From: Chris Marx <cmarx@chiltonwi.gov>
Sent: Wednesday, August 9, 2023 10:47 AM
To: Campoli, Karen L - DNR; Ron Wolf; David DeTroye
Subject: RE: Chilton Plating Site

Subject: Chilton Plating Site

Attached is a map of the former Chilton Plating Site in Chilton. As discussed on the phone today, the City would like to utilize a portion of that property to facilitate recycling of the roadway for the upcoming street reconstruction project occurring in that area. The area to be used for discarded concrete and asphalt storage is outlined in red. The piles would then be recycled on site (crushed) and used for road base on the project. Also, as discussed, the City would require the contractor to line the area with silt sock to minimize runoff of dust and debris from the recycling process.

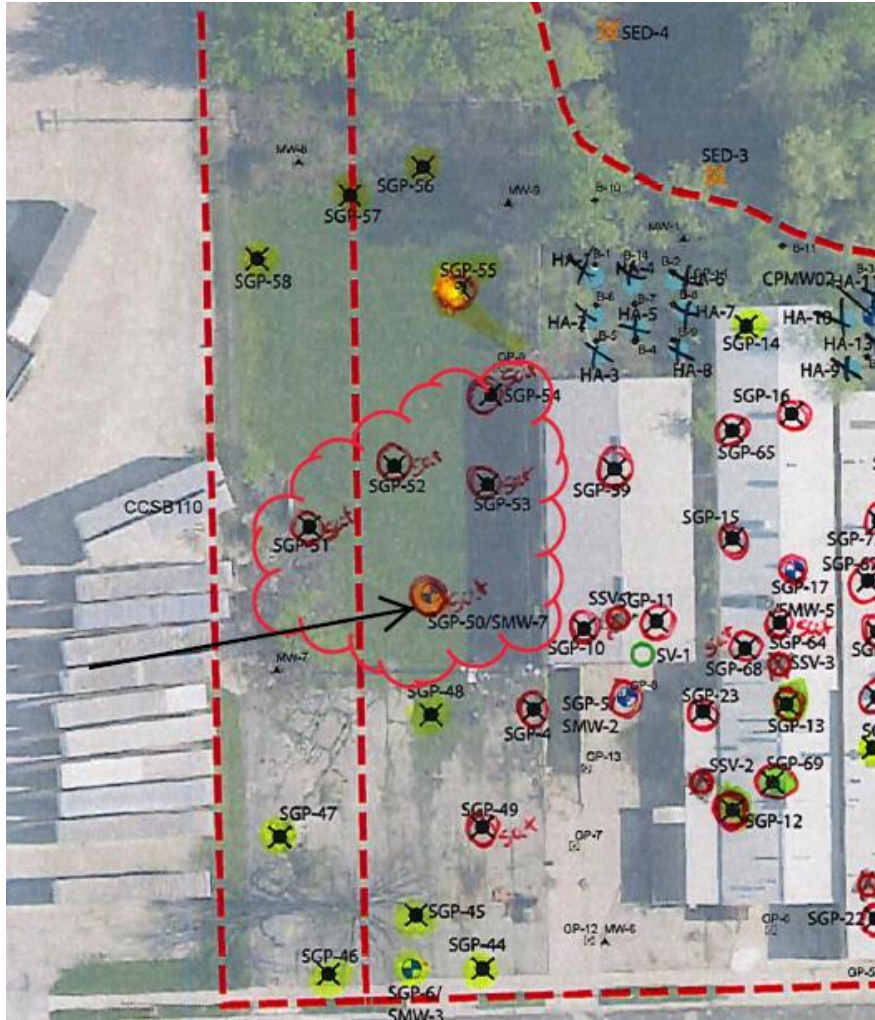
Thank you for the figure and description for the aggregate storage. I'd recommend trying to keep the aggregate storage on the former foundation (an impermeable surface) as much as possible since there is shallow soil contamination, specifically a direct contact exceedance at SGP-50/SMW-7 (indicated with the arrow in figure below). This direct contact exceedance was detected in the 0-2 feet. My concern is if the aggregate is placed in this location, if any soil is scraped up when the aggregate is removed to be used in the road, then there is a potential for cross-contamination and would then have contamination brought off-site into the roadway. Limiting the storage and activities to the impermeable surface areas will help reduce the risk for cross-contamination.

I would also recommend marking or flagging the monitoring wells to make them more visible for any machine operator that will be at the site. As a reminder, if any monitoring wells are lost or damaged during the aggregate storage activities, the wells would need to be replaced and/or reinstalled.

Thanks for the response, and we will make alterations to our plan to address the additional concerns.
